Structural Schematic Design Report

Meriden – Senior School Campus New Centre for Music and Drama

Allen Jack + Cottier / May 2019

181478

FLOOR | Level 1

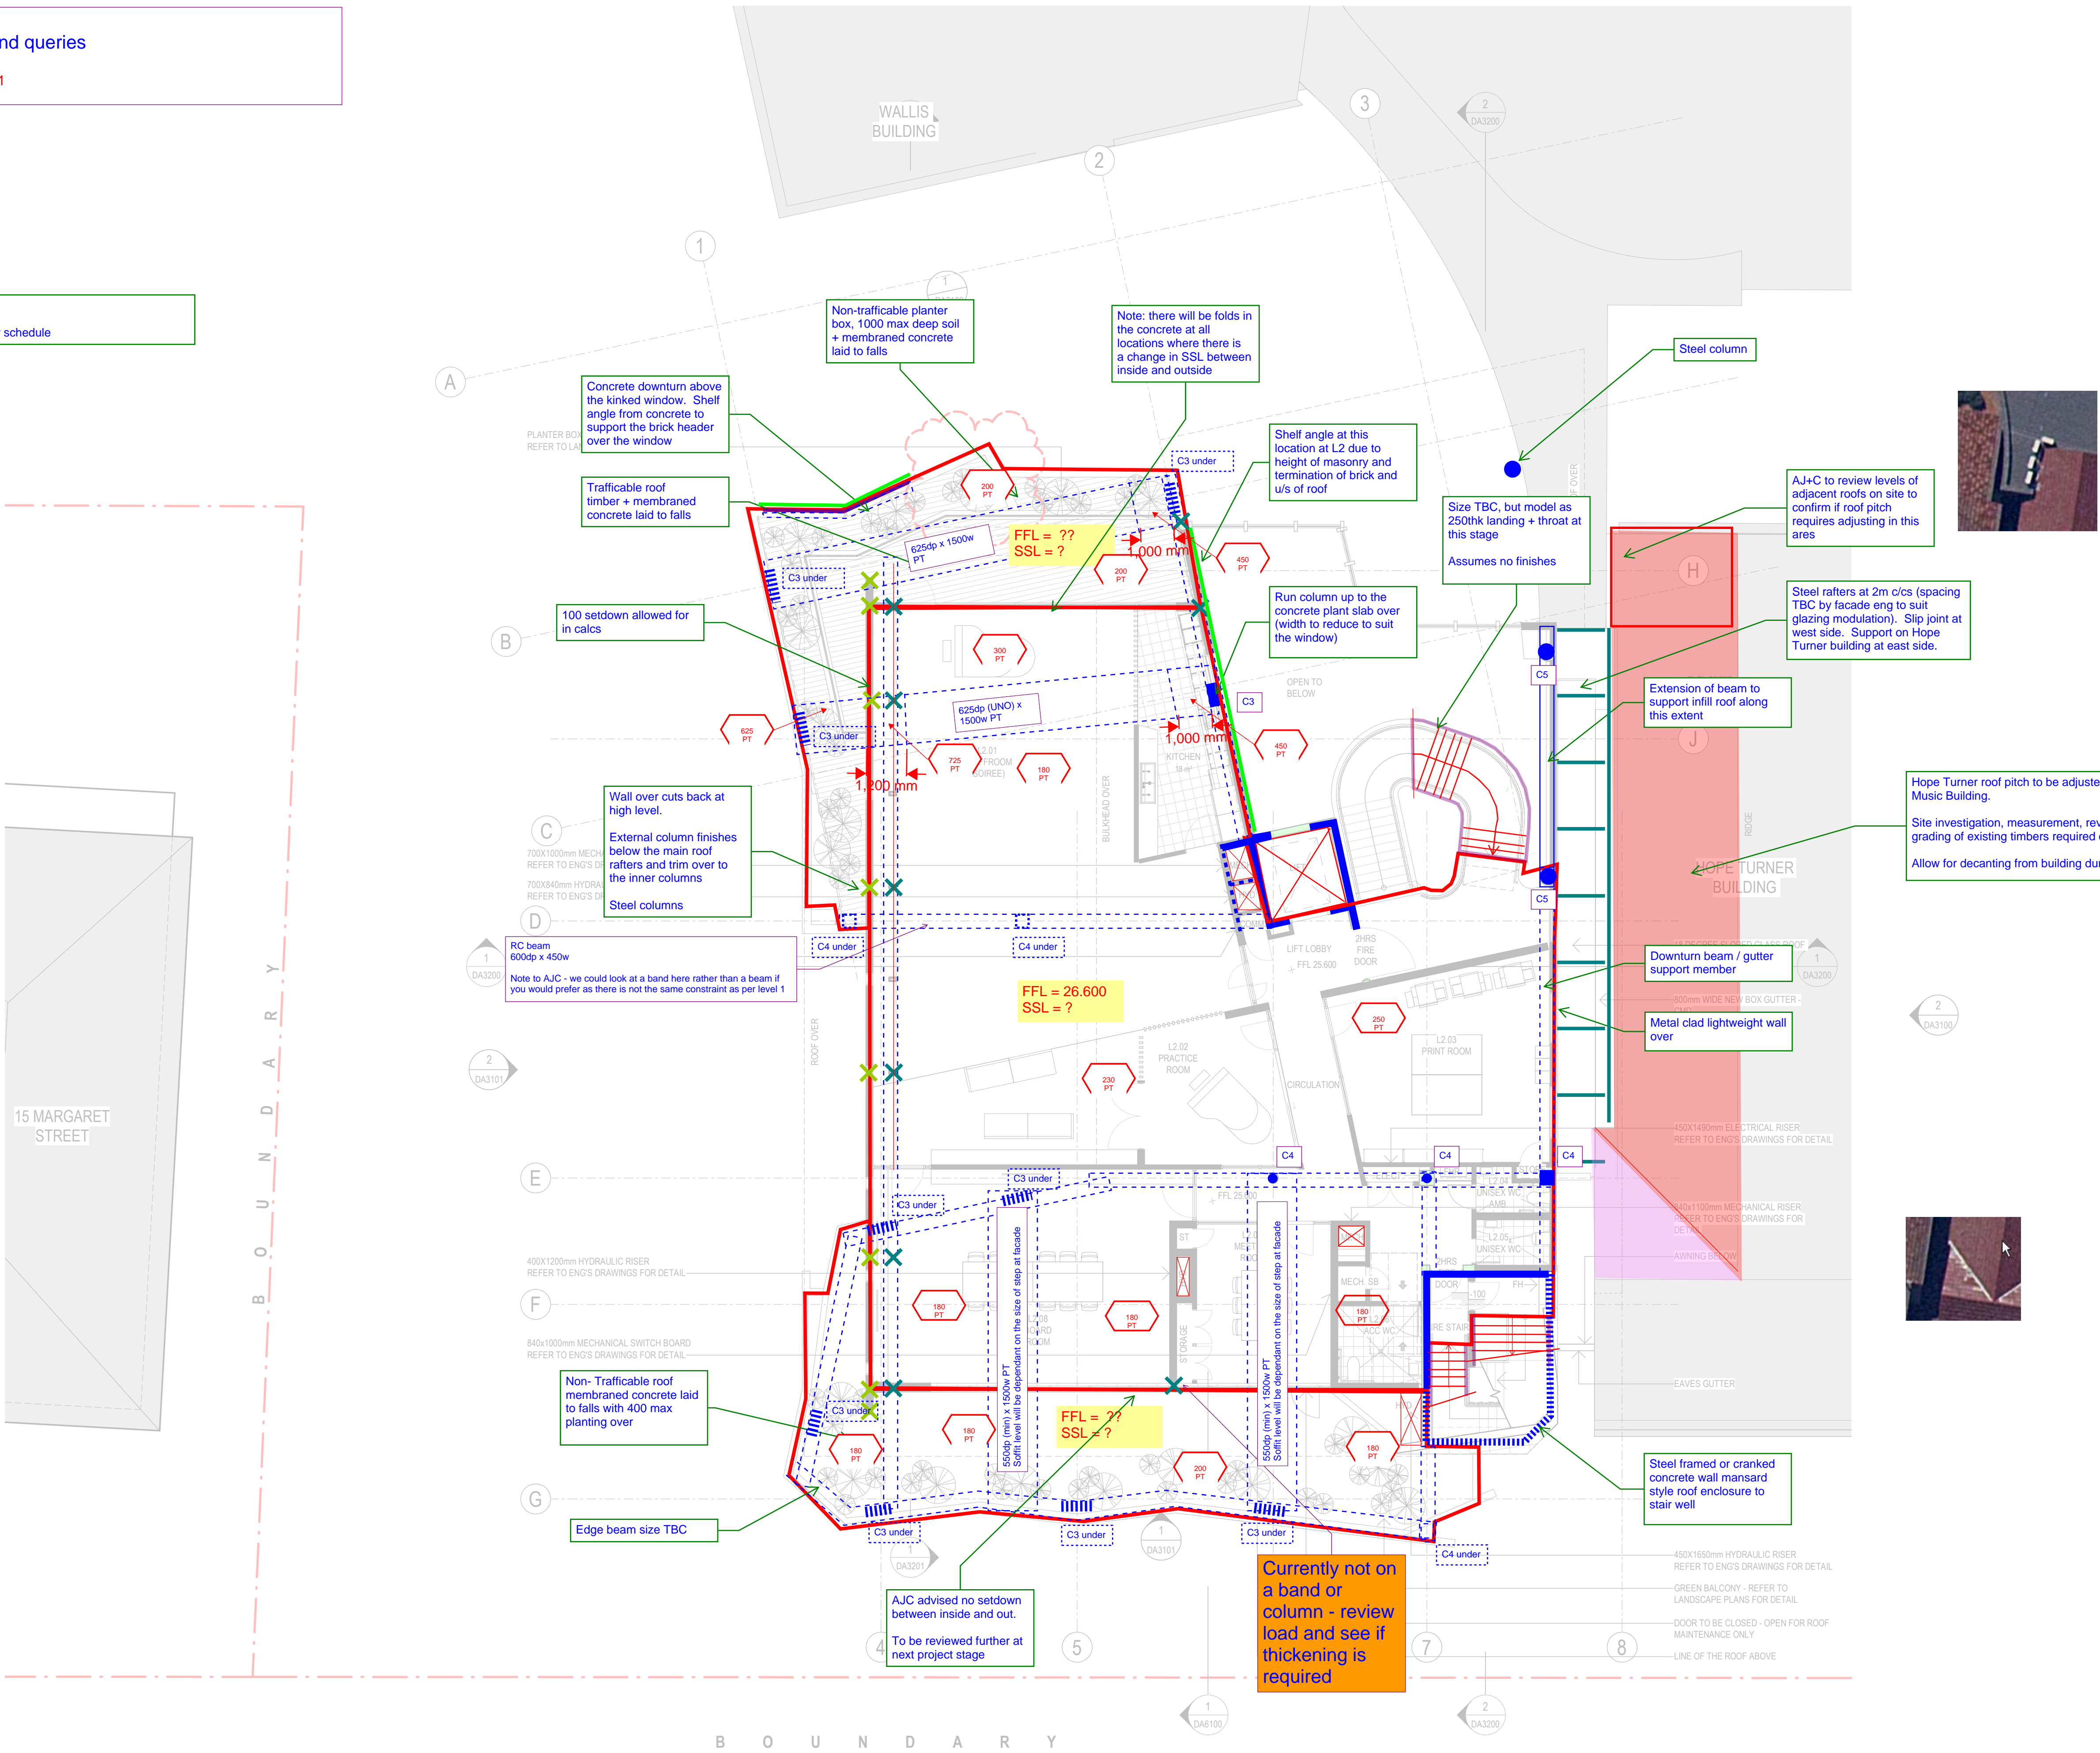
TTW structural overlay
Preliminary information and queries
181478
~~SK190314.02~~ SK190403.01

CMD / HOPE BUILDING INTERFACE

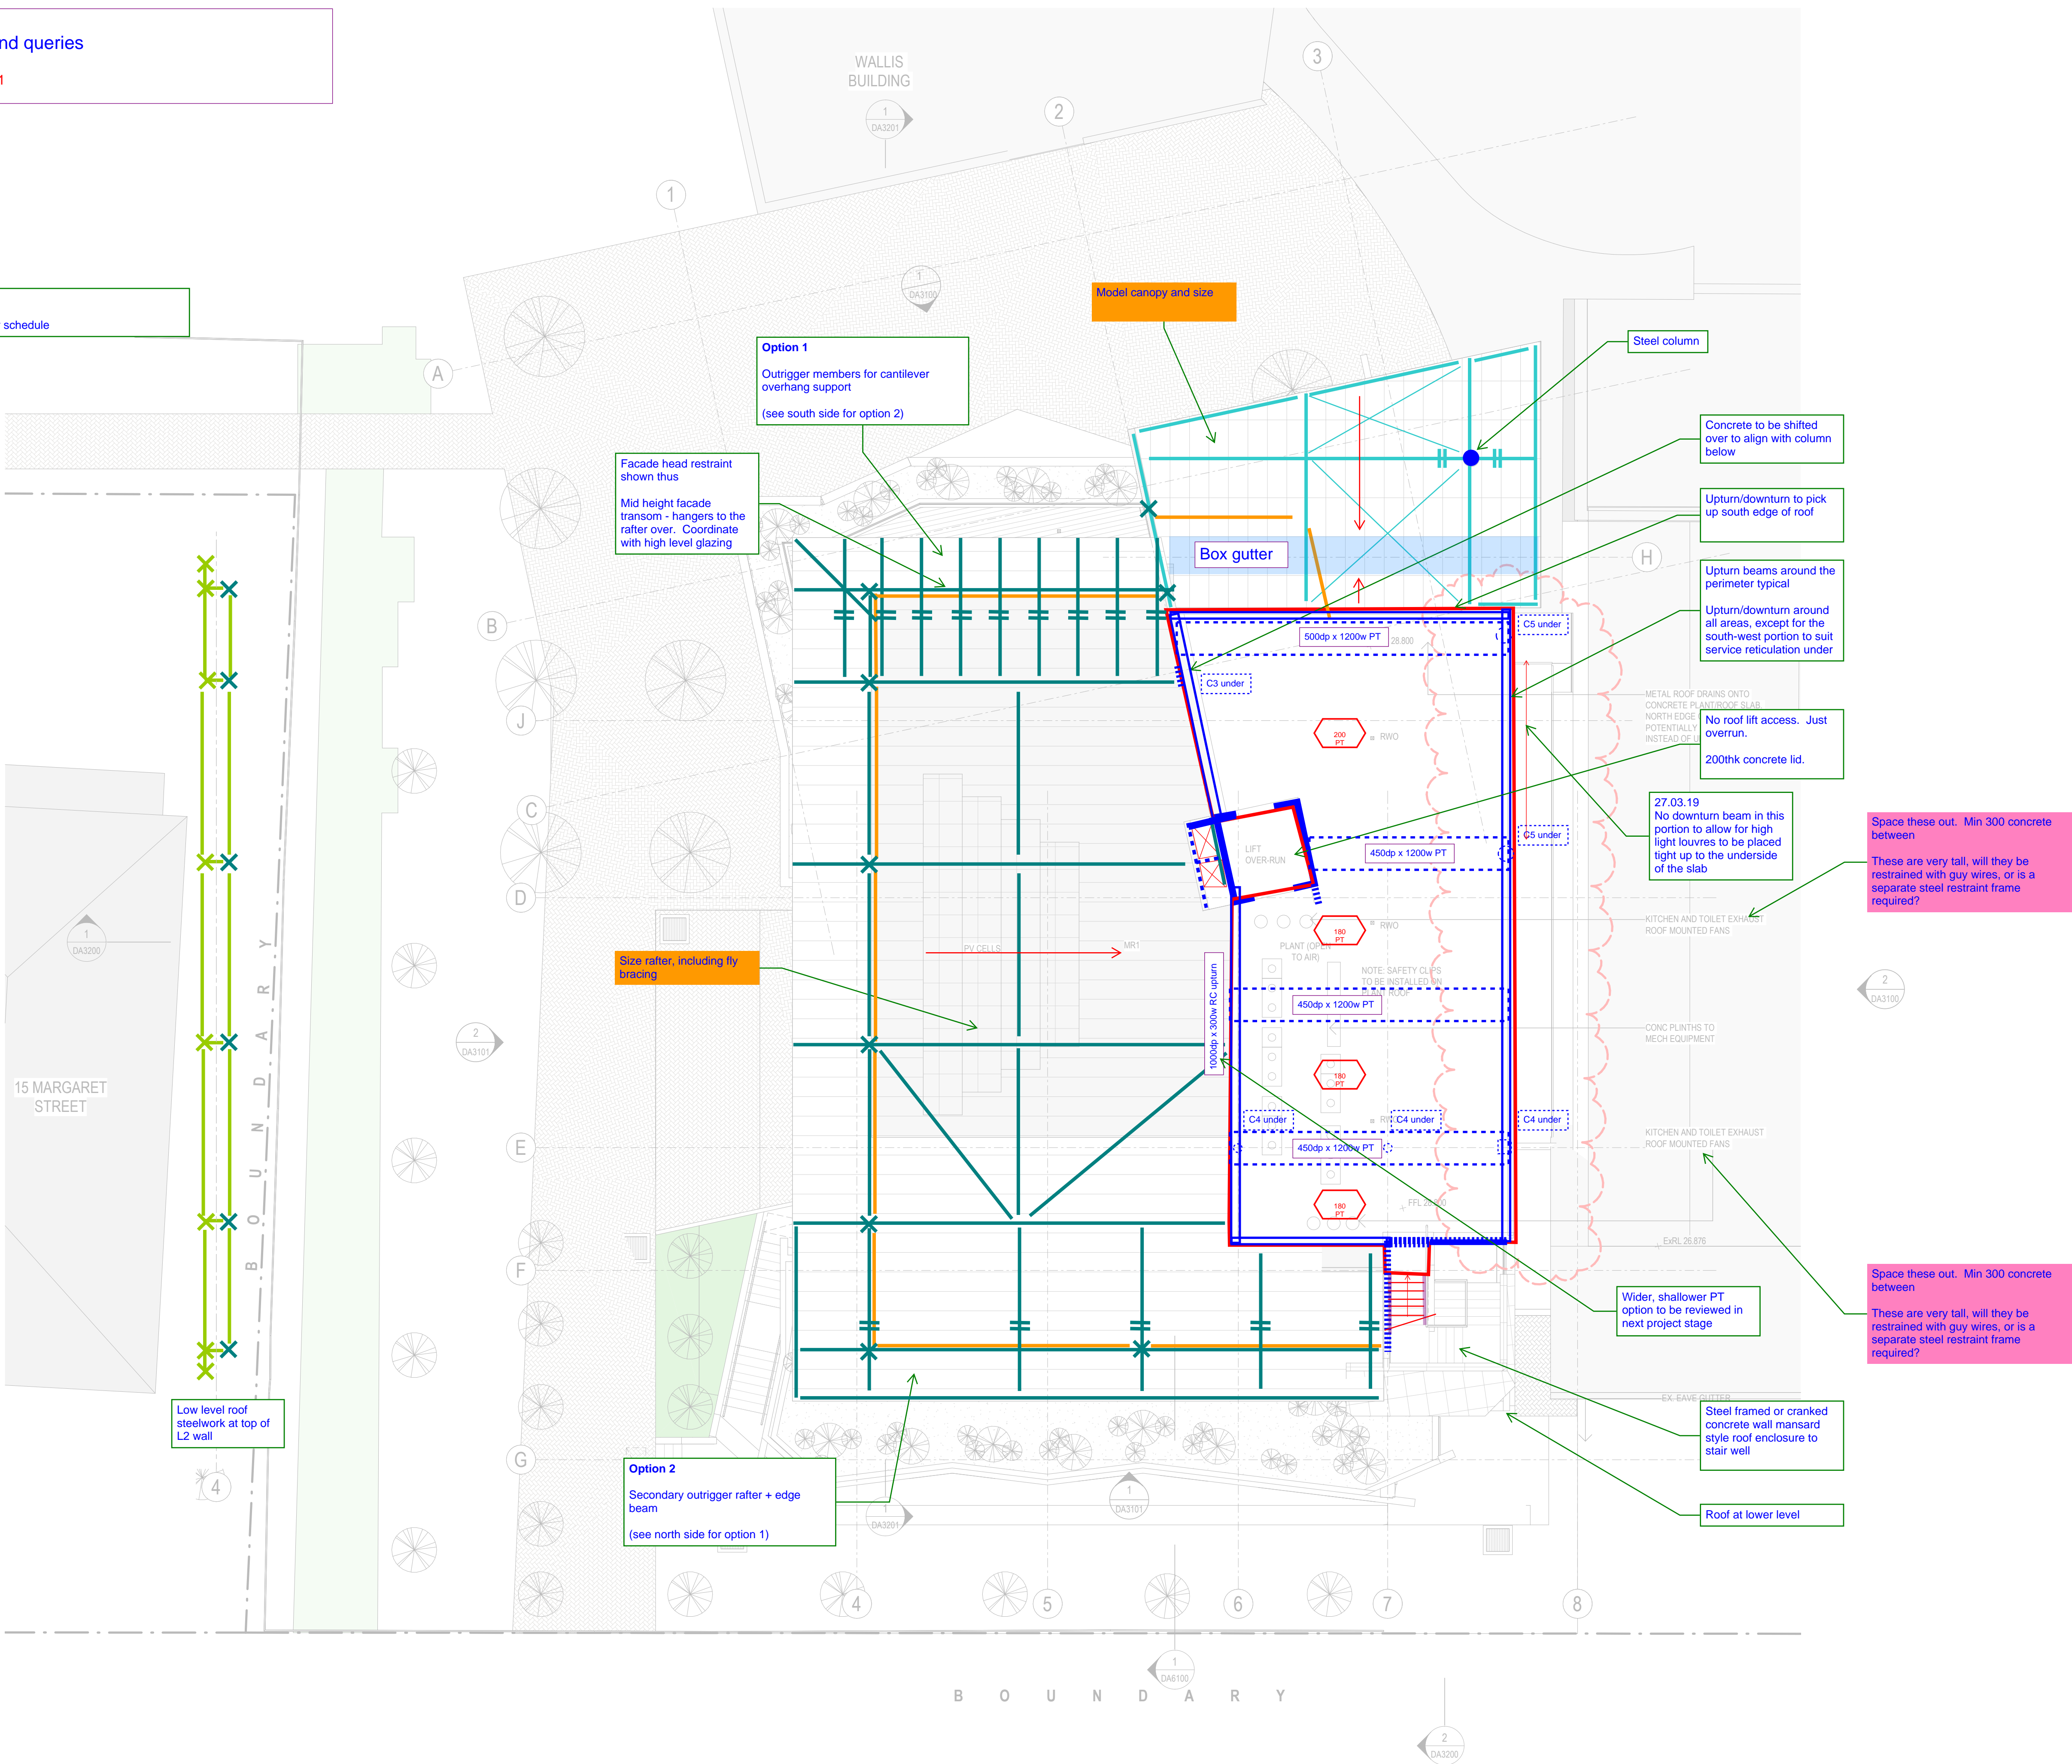
Corbel size to be refined as far as possible
